Bulker Q&As and CIs on the IACS CSR Knowledge Centre

Figure : Variable cross-section stiffener

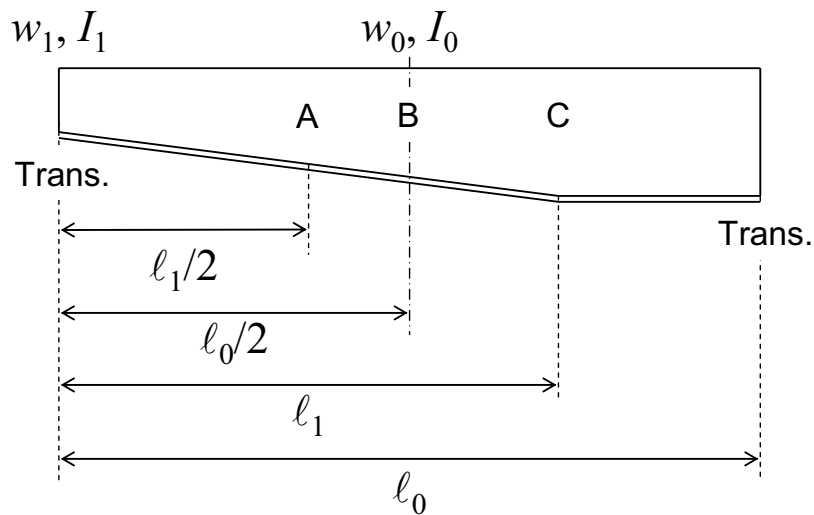
We would like to confirm a way to apply the requirement of this sub-paragraph to a structural member shown in the attachment.

(1) Which position, A, B or C, shown in Figure, is to be selected to calculate w_0 and I_0 ?

We consider that position B is suitable for this requirement. Please confirm.

(2) Which position, A, B, C or else, is to be considered when the requirement of net section modulus of ordinary stiffeners, w , is applied?

We consider that position A is appropriate for this requirement. Please confirm.

KC#582

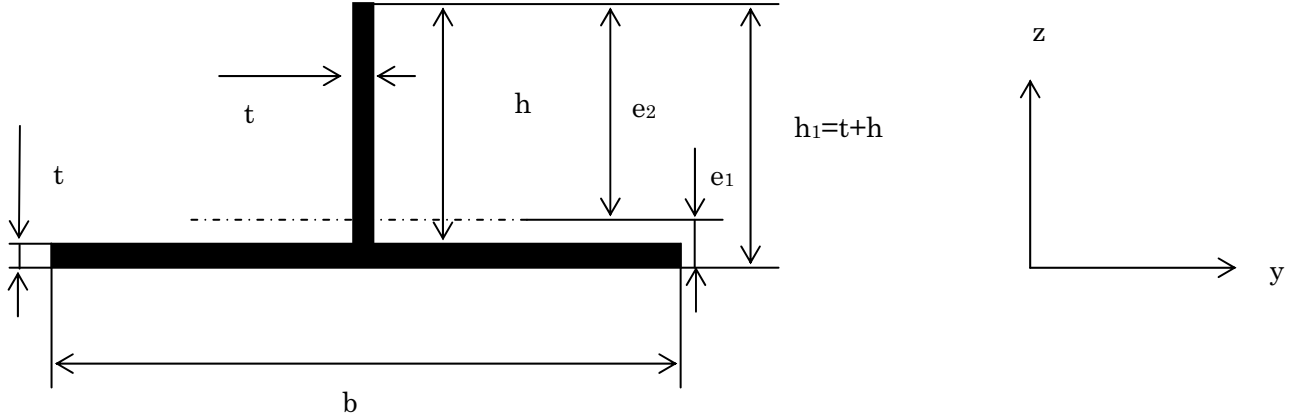
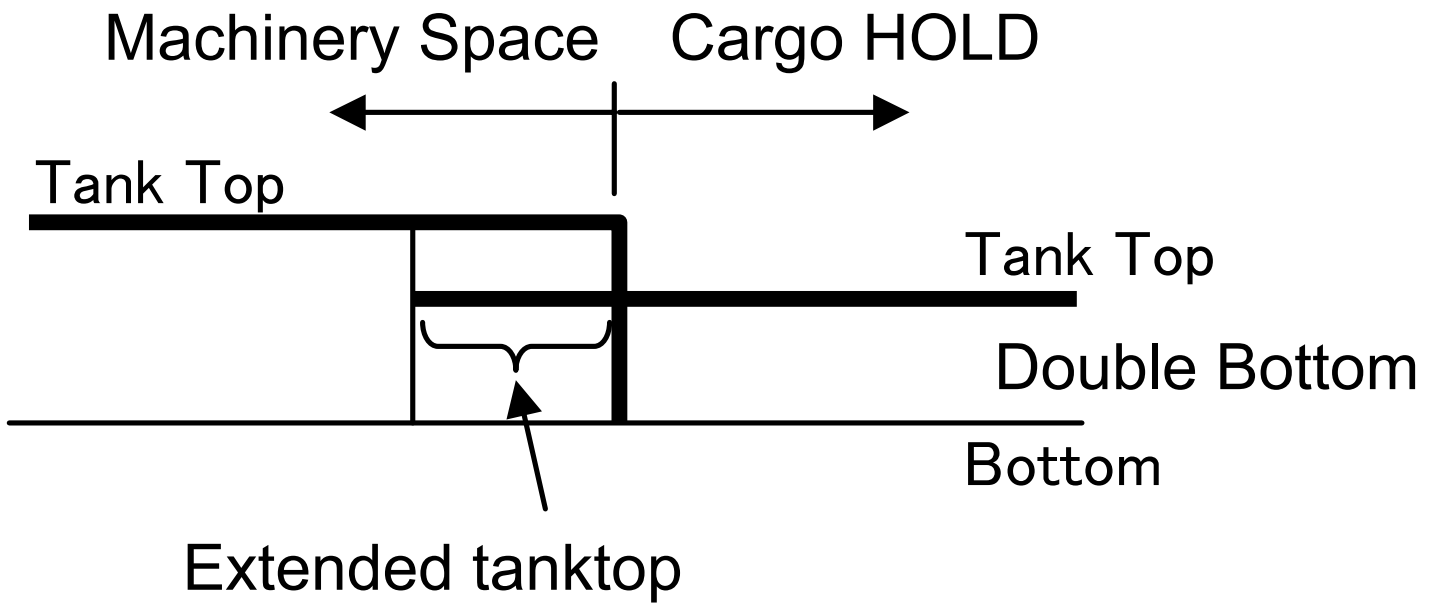
Double bottom Floor of E/R

The background of formula for net section modulus of web stiffener in Ch 6 Sec 2 [4.1.2]

Model Web stiffener is flat bar type and the web thickness of the web stiffener is equal to that of the attached plate

In this case, the moment of inertia of the stiffener with attached panel is given by the following equations.

KC#1074

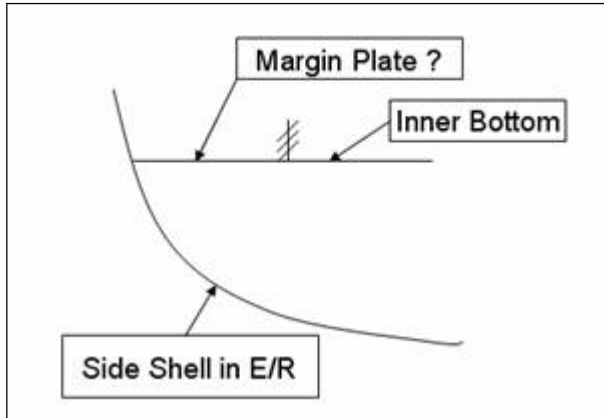
1039	9/5.2.2.1	CI	Requirement of ballast hold and hatch cover of the ballast hold	2010/5/17	Regarding the requirement of Ch.9, Sec.5, 2.2.1, we would like to confirm that a ballast hold is not included in ballast tanks and other tanks, and a hatch cover of the ballast hold is required to be weathertight.	Your interpretation is correct. A hatch cover of the ballast hold is required to be weathertight.	
1074 attc	9/3.2.2	Interpretation	Definition of Margin Plate	2010/11/15	<p>There is no definition of "Margin Plate" in CSR Bulk Carrier.</p> <ol style="list-style-type: none"> 1. Rule Application of CSR Bulk Carrier: Chapter 9, Section 3/2.2. Table 1: Minimum Thickness Application of Margin Plate. 2. Since there is no definition about "Margin Plate" in CSR Bulk Carrier Rule, we are using the "Margin Plate" definition in CSR Tanker (Ref. Sec.4/ Table 4.1.1) 3. According to the definition of terms in CSR Tanker, we may think of the following two cases; Case 1 & Case 2 (see attachments) 4. Does you consider both cases are Margin Plate? or One of two cases is Margin Plate? 	<p>The definition of Margin Plate in Ch9/Sec3/Table 1 should be given and in line with CSR OT in which the definition comes from IACS Recommendation 82, "Surveyor's Glossary, Hull terms and hull survey terms". Both Case 1 and Case 2 are Margin Plate. A corrigenda will be considered.</p>	Y
